THE MESAS OF STONE OAK

PRELIMINARY OVERALL AREA DEVELOPEMENT PLAN #390

Re: Mesas of Stone Oak POADP # 390B

RE: Mesas of Stone Oak, POADP #390 Revision

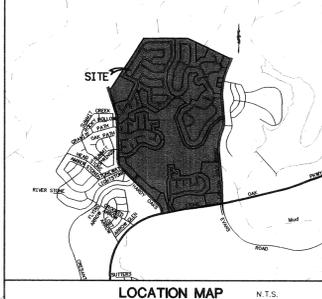
- Based on the topography, a Flood Plain Study and drainage review will probably be required during the platting process.
- In consideration of public safety and convenience, excessive grades by reason of topography should be avoided in street layouts and arrangements.

- This development will probably need to conform to requirements associated with development over the Edwards Aquifer. For additional information about these requirements you can contact SAWS at 704-7305.

- Access and R.O.W. issues along State facilities will need to be resolved with the Texas Department of Transportation (TXDOT). For information about these requirements you can contact TXDOT at 615-5814.

- This development will need to comply with tree preservation ordinance #85262. For information about these requirements you can contact Building Inspections at 207-7102.

- It will be expected that you will plat all of the property depicted in your POADP, to include: floodpains, drainage areas and open space.
- I would encourage you to work closely with the school district, so that they can plan accordingly.

A fax transmittal sent to you on October 15 addressed concerns voiced by city staff. One of the concerns called for a connection between Champions Ridge Unit 3 and Mesa Grande Unit 3. In your response to this concern, your letter dated October 18, 1999 indicated that a 30' utility, water and *pedestrian* access easement connected the two developments. The connection that should be between these two developments is a *vehicular* connection. This is in keeping with the Unified Development Code Section 35-4101 which states "Street layout shall be devised for the most advantageous development of the entire neighborhood development". Also, Section 35-4103 states that "Where adjoining areas are not subdivided, the arrangement of streets in the subdivision shall make provision for the proper projection of streets into such un-subdivided areas." Master Plan Policies, page 42, Goal 1, Policy 1b(1) calls for *pedestrian safety and comfort, transit access, street level amenities, and circulation between neighborhood centers*. Page 43, Policy 1c(4) states *encourage street patterns that promote multiple pedestrian and vehicular access and do not contribute to collector street congestion*.

This connection is in keeping with the original POADP for the Mesas of Stone Oak, # 390, accepted Nov. 16, 1993 which shows a collector running across the northern portion of the site. It accesses Hardy Oak and Evans Rd and connects Mesa Verde, Mesa Grande and Mesa Bluff.

On the current plan, staff had also asked for a connection between Mesa Grande and Mesa Verde. Staff has concurred with your views concerning this connection and acknowledge the condition of the rough terrain in the area. Public Works has indicated they are satisfied with any traffic requirements.

Although two plats out of this POADP have moved forward, the connection mentioned above between Champions Ridge Unit 3 and Mesa Grande Unit 3 will be required before any more plats can be submitted to the Planning Commission.

2. a. Connection between Champions Ridge and Mesa Grande was and is covered by the 30 foot utility , water and pedestrian access easement as requested and granted on the Champions Ridge POADP.
 - b. Connection between the Mesa Grande and Mesa Verde would not be of any significant use, as the two subdivisions only border one another for approximately 400 feet, which for emergency access the likelihood of that area being block would be very good if the main entry was blocked. To move a connection any further back includes a third property owner and very rough terrain. Both subdivisions have another source of access and / or emergency access if needed.

3. Pedestrian connection to connect residential areas with the elementary school is not feasible due to the terrain and liability. The average slope coming from the back of these lots to connect together is 20% or more and not suitable for a elementary school age child to be walking. This does not take in consideration the fact that a large portion of this canyon area is not habitable and will in all likelihood stay in its' natural state and much too dangerous with the possibility of snakes and other natural habitants for school children to be walking. The liability of the homeowners, the homeowners' association, and the individual landowner is too great. If the City requires this, it would also put them liable.
